RFI 342

RFI O-M LM 00342 Curb for Kitchen Con

SHEET TITLE
MECHANICAL DETAILS

SHEET IDENTIFICATION NUMBER
M-503

A.C. UNIT ANCHORAGE - BUILDING A — A

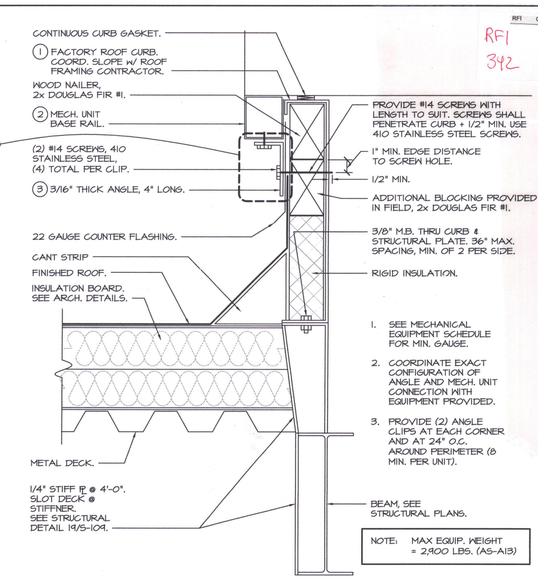
Sheet AD3-A141A & ASI12.141A calls out Detail A/M503 for the curb at kitchen compressor unit.

Please confirm that the curb for the kitchen compressors is to be metal as identified on Detail A/M503.

After a review of the drawings and details, we have discovered some items that need clarification. Sheets A-141A, AD3-141A, ASI 12-141A all called out for the same detail reference of Detail A Sheet M503. This installation and mounting of the Compressor Rack unit requires the coordination of the drawings and descriptions given by the Kitchen Consultants information found on Sheet K-4 and with the revision of APR 36 K-4.
While the Detail A Sheet M503 will facilitate a similar installation of the Compressor Rack, special attention must be given to the location of support legs or members that bolt to the curb.
It calls for a steel angle to provide an "anchorbolt attachment per mechanical". Detail A Sheet M503 would be difficult to provide and only be similar. More clarification is required for proper support. We would suggest that a concrete pad be provided as the installation would be provided per Structural Detail 14 Sheet S109 and Detail M509 using 3/8" dia x 3 ½" embed HIlti KB-TZ bolts spaced per Compressor Rack detail on Sheet APR 36 K-4.

As provided on the Architectural Roof Plan Drawings, the curb for the future Outdoor Compressor for Data room equipment need not be installed at this time. However, the Structural drawings sheet S202A delineates the supports required and the curb.
The work for this future unit's "expected" curb may be omitted and provided at the Cold Box Compressor Rack.

Clarification, that Make-up Air Units MUA/1 & MUA/2 definitely indicate concrete curbs per Details Sheet M509 & Detail 14/S109. No provisions have been provided to install these units over steel fabricated curbs.
Field Verified condition, and possible resolution to construct the curb different than shown on the drawings must come via the Construction Manager (from the Contractors).
The Proposal will be re-evaluated and construction may not proceed until DSA reviews it in a CCD if the structure is affected by this revision.
